Town Council Work Session

To: Reagan Parsons, Town Manager
From: Alaina Mallette, Senior Planner
Subject: AR-24-22, Southern Pines Village Brucewood Road
Fort Bragg Federal Credit Union
Date: February 28, 2023

FORT BRAGG FEDERAL CREDIT UNION
SOUTHERN PINES BRANCH
105 BRUCEWOOD ROAD
SOUTHERN PINES, NORTH CAROLINA

A-201
SHEET 5 OF 10

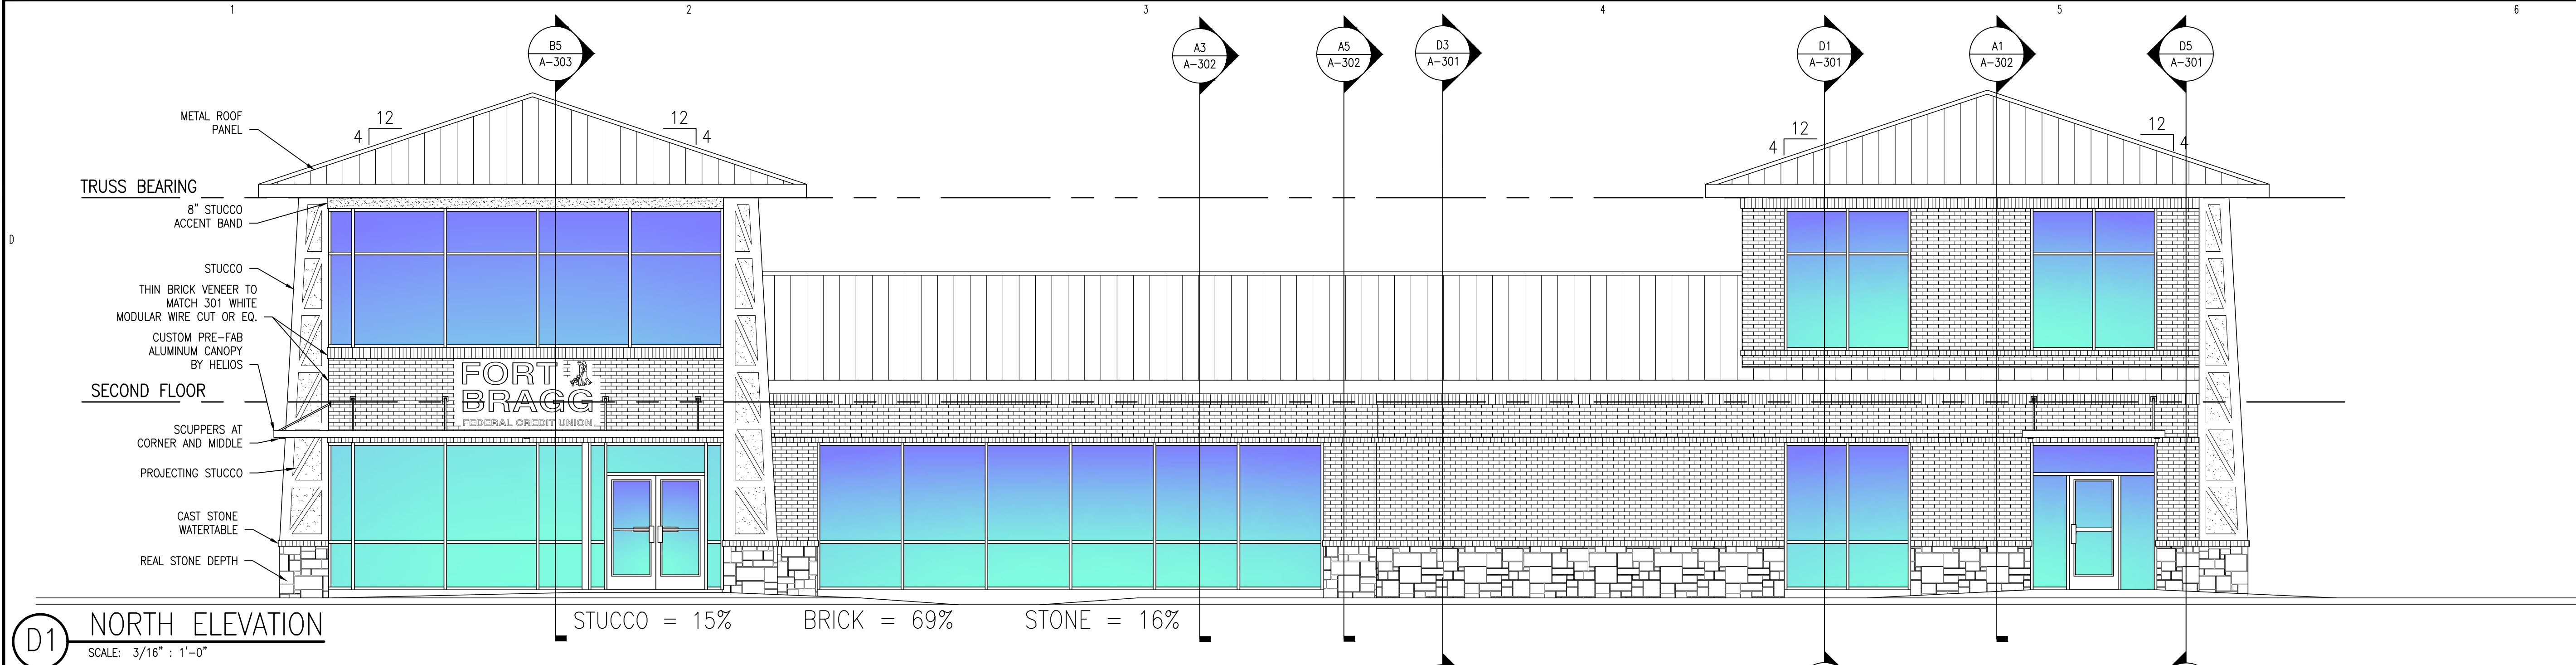
1. The exterior elevations (Sheet A-201) says sheet 5 of 10. If the other sheets are still being used for architectural guidance, can you submit those to me for review, as well?
Those sheets are specific to the building construction drawings and include interior details and other items that are not relevant to the ARB submission. Would be happy to provide them if you want to see them. I will have to get them from the architect.
2. I notice that there are callouts A1, D1, etc. on Sheet A-201. Do you have a reference table that explains what those are referring to? Perhaps those are located on one of the other 10 sheets in the original packet that we haven't received. Those are the labels for the specific elevations. D1 is the North Elevation, B1 is the East Elevation, etc.
3. What is the distance between the two entries? I believe my calculation is off, and would

2. I notice that there are callouts A1, D1, etc. on Sheet A-201. Do you have a reference table that explains what those are referring to? Perhaps those are located on one of the other 10 sheets in the original packet that we haven't received. Those are the labels for the specific elevations. D1 is the North Elevation, B1 is the East Elevation, etc.

1. The exterior elevations (Sheet A-201) says sheet 5 of 10. If the other sheets are still being used for architectural guidance, can you submit those to me for review, as well? Those sheets are specific to the building construction drawings and include interior details and other items that are not relevant to the ARB submission. Would be happy to provide them if you want to see them. I will have to get them from the architect. [See DropBox Link.](#)
<https://www.dropbox.com/sh/m4hu26il2k4tahm/AAB02VbjnAMvuaiwA6VxGoIa?dl=0>
